**ASHLAND PLANNING COMMISSION
REGULAR MEETING
February 11, 2020
AGENDA**

**CITY OF
ASHLAND**
ASHLAND PLANNING COMMISSION
REGULAR MEETING
MINUTES - *Draft*
January 14, 2020

A. **PLANNING ACTION: PA-APPEAL-2019-00010 appealing PA-T1-2019-00080**

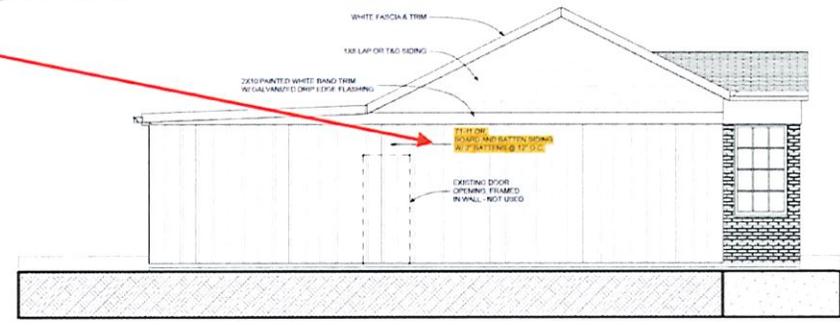
4) *Roof Profiles in this area (Over the office) do not properly drain. Provide cricket, or extend the center roof section toward the exterior to prevent roof from trapping water in the interior.*

The front roof now forms one continuous plane over the two garage bays. This plane has been continued to meet the office roof, cricketing appropriately to allow proper drainage of water.

1 SOUTH EAST ELEVATION-NEW
SCALE: 1/4" = 1'-0"

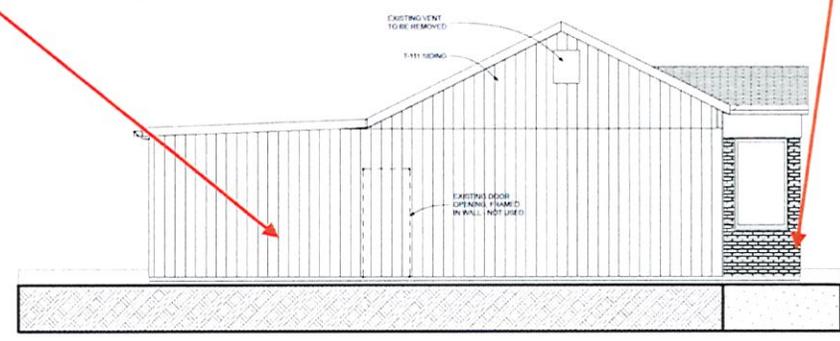
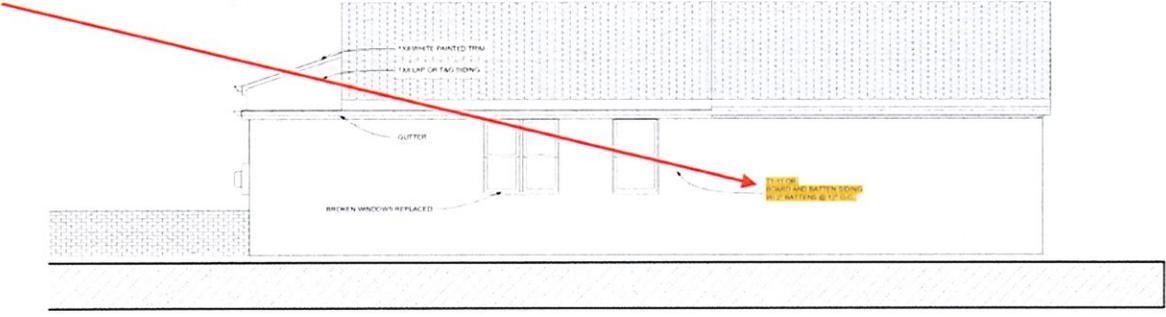
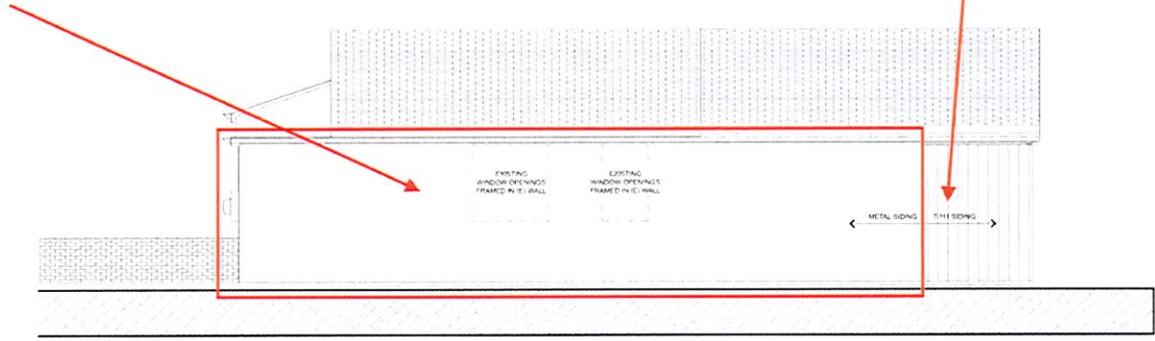
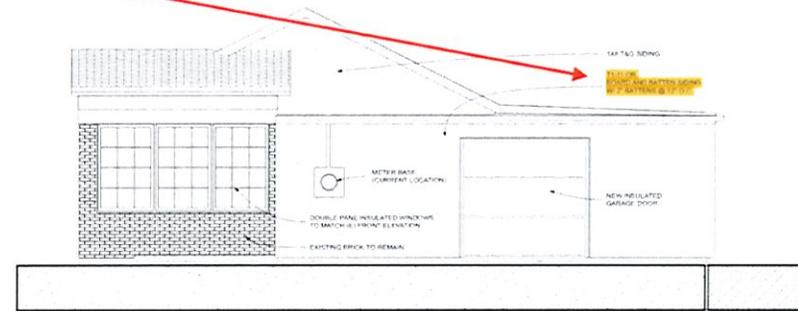
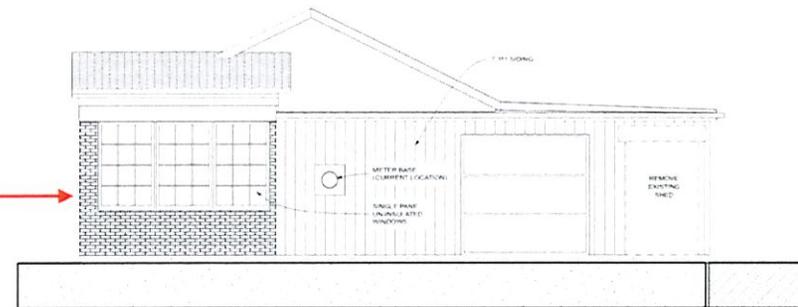
The City's Community Development Department and the Historic Commission did not effectively review the plans nor the evidence submitted which illustrated that the original siding is a combination of vertical metal siding and vertical T1-11 siding.

**Compatible New Siding to match original, T1-11 OR,
BOARD AND BATTEN SIDING W/ 2" BATTENS @ 12" O.C.**

**Compatible New Siding to match original, T1-11 OR,
BOARD AND BATTEN SIDING W/ 2" BATTENS @ 12" O.C.**
